## Avon Parks – Burnett Park and Winton Meadows Park Addendum 02

DATE: Friday, February 20, 2026

PROJECT NAME: **Burnette Park and Winton Meadows Park**

The extent of this addendum is as follows:

**1 WOODLAND POD: FRAMING PLAN, PLAN, & FRONT ELEVATION-ADD ALTERNATE**  
Scale: 3/4" = 1'-0"

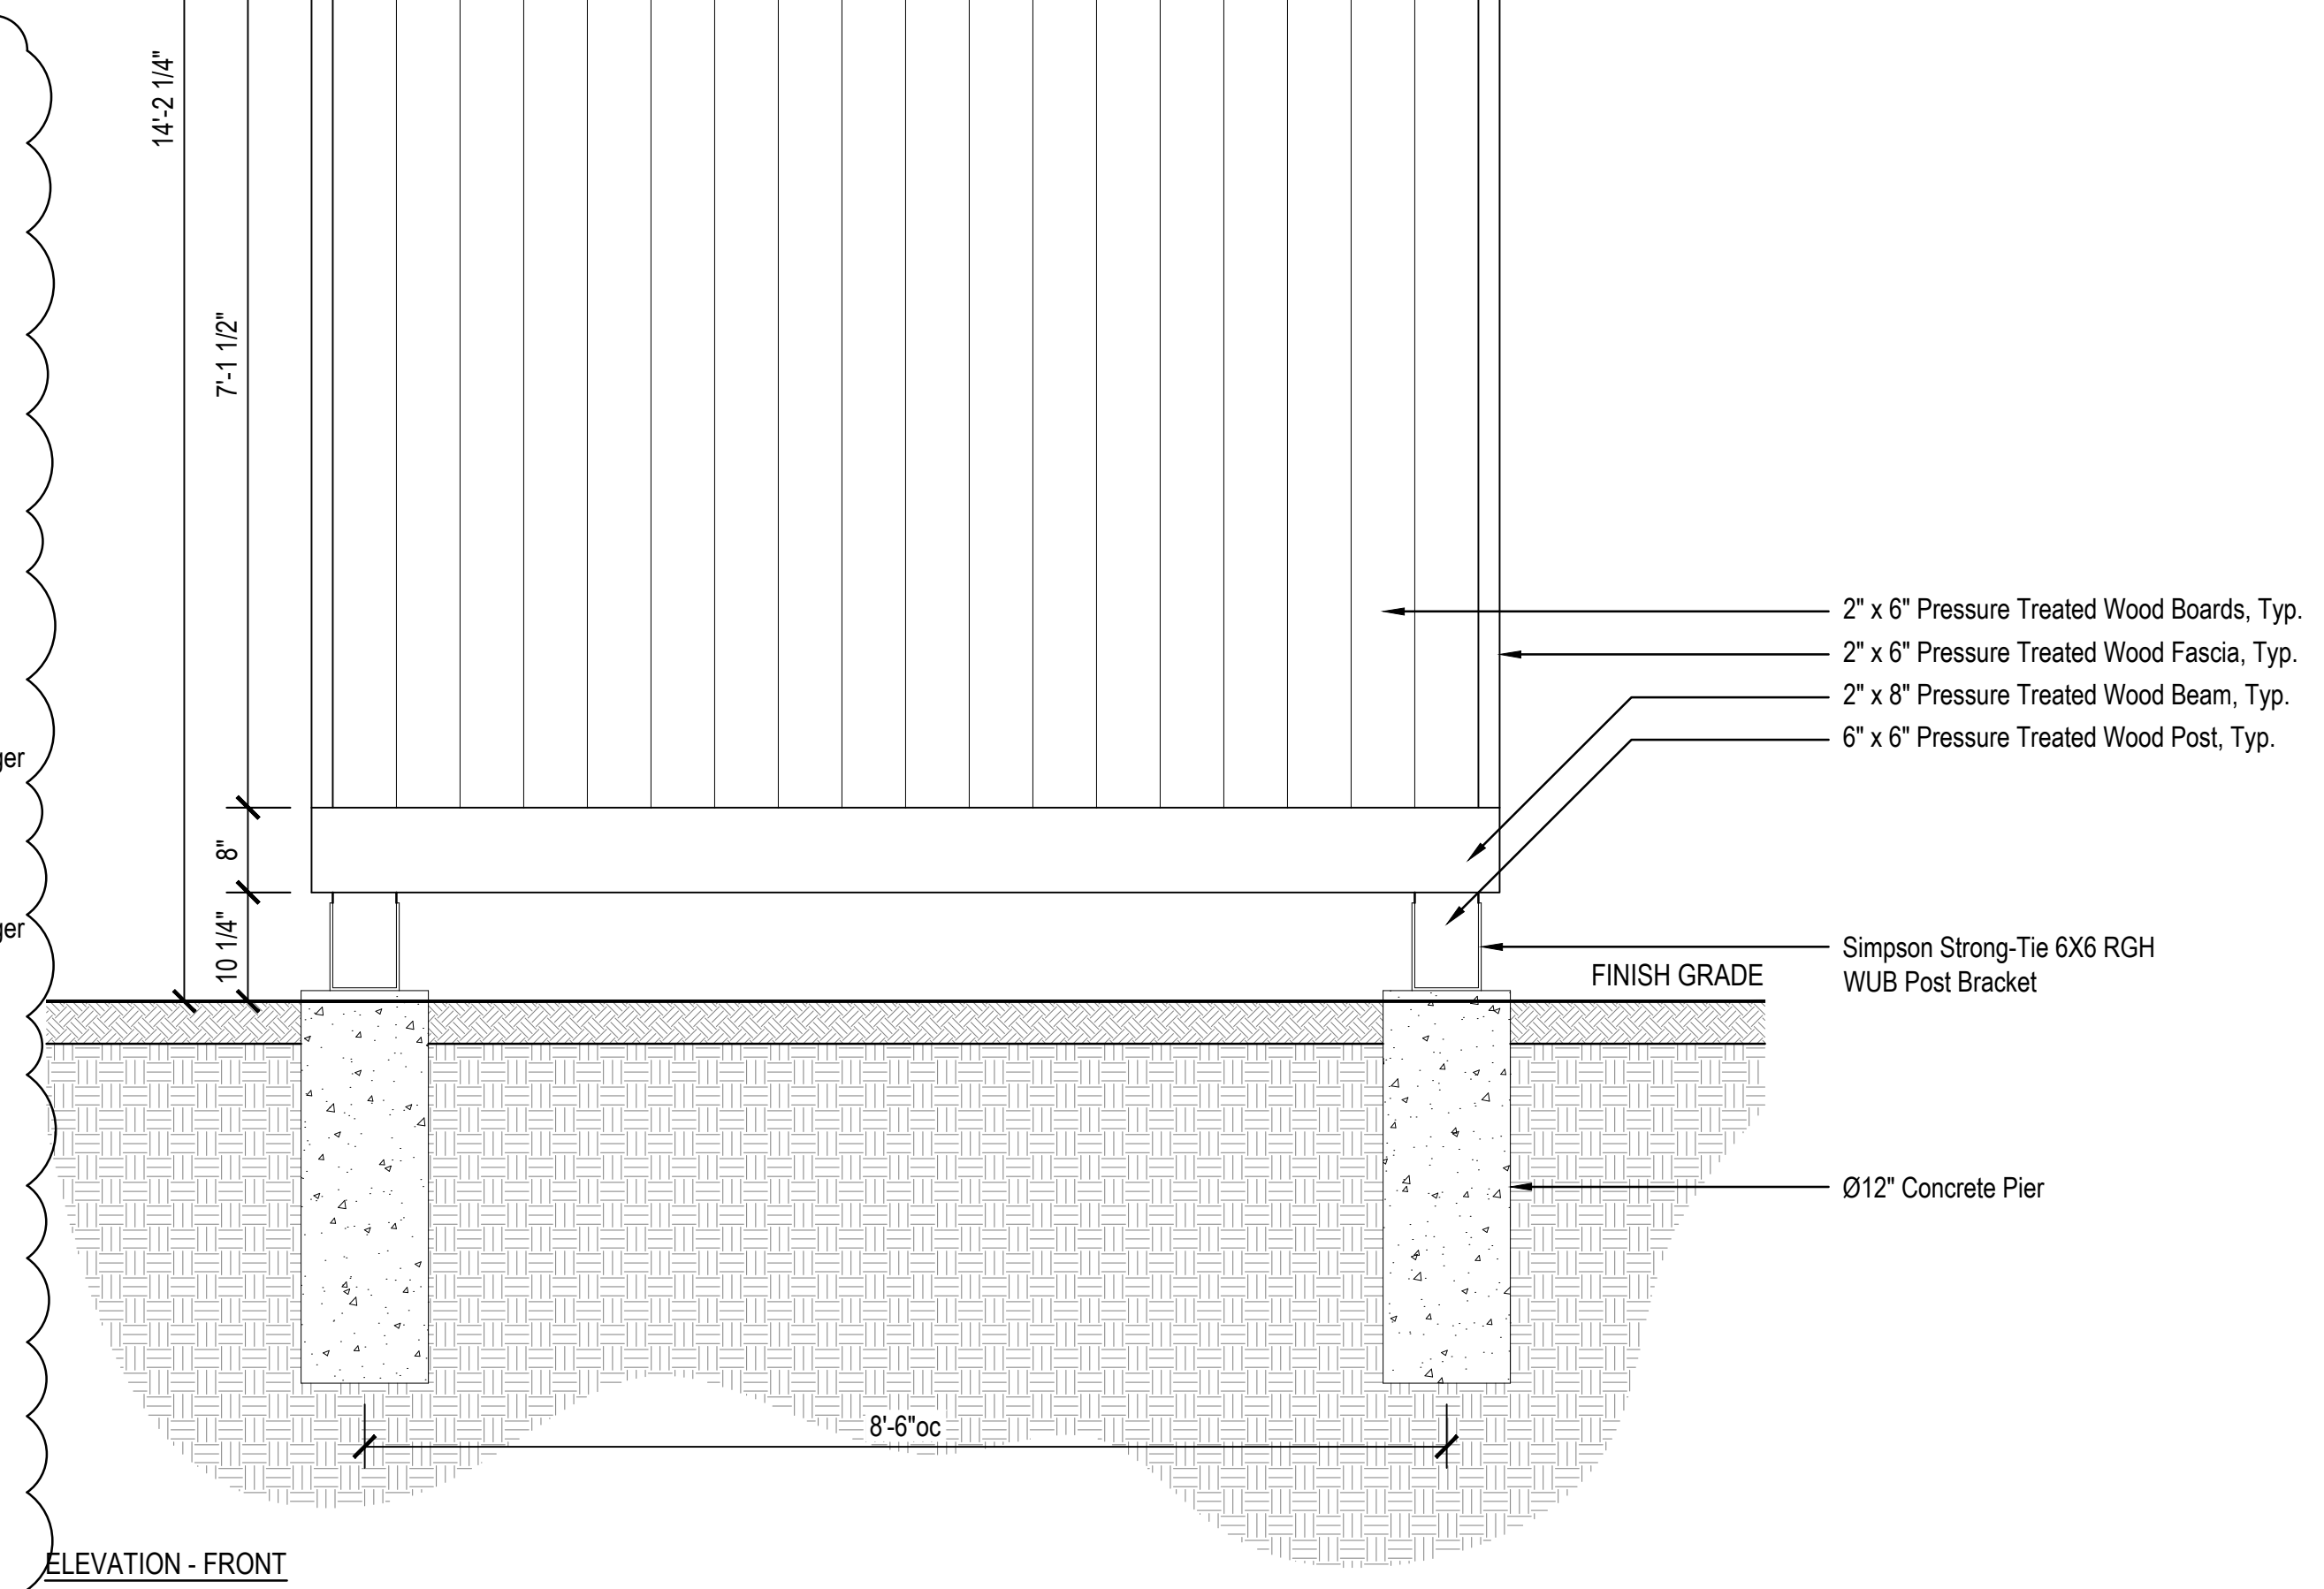
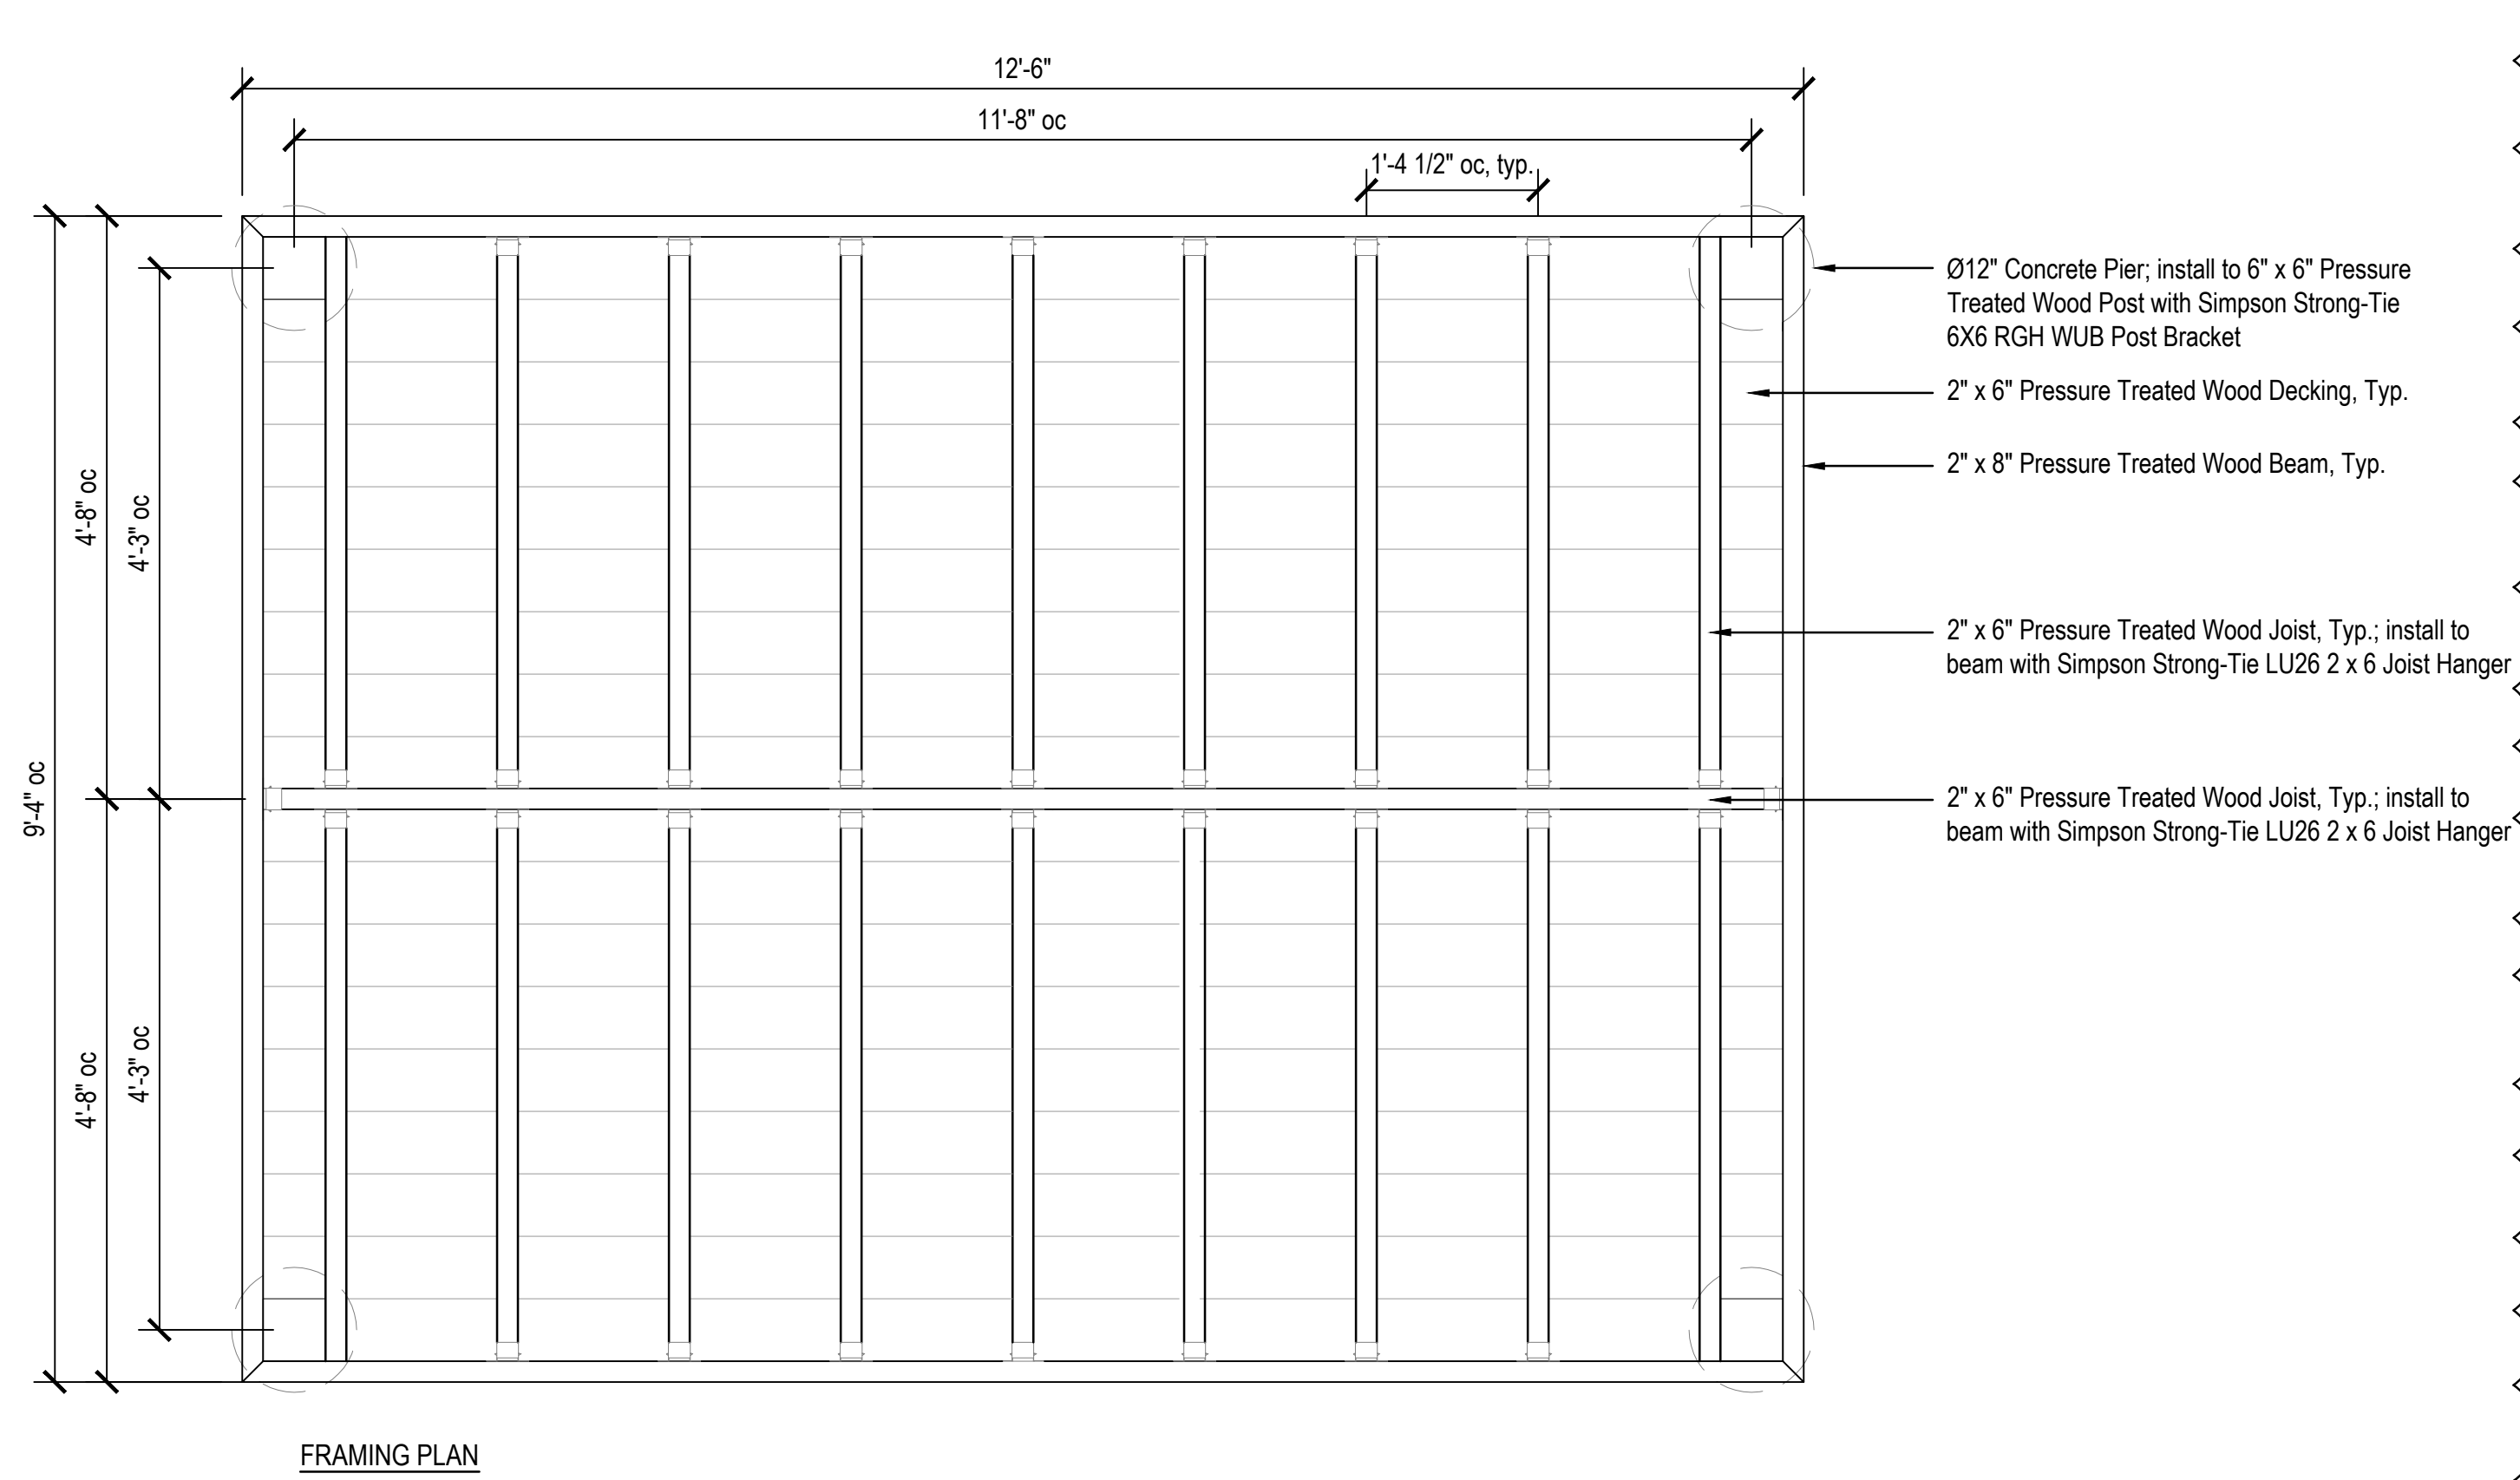
- a) Joists adjusted to be perpendicular to structure floorboards.
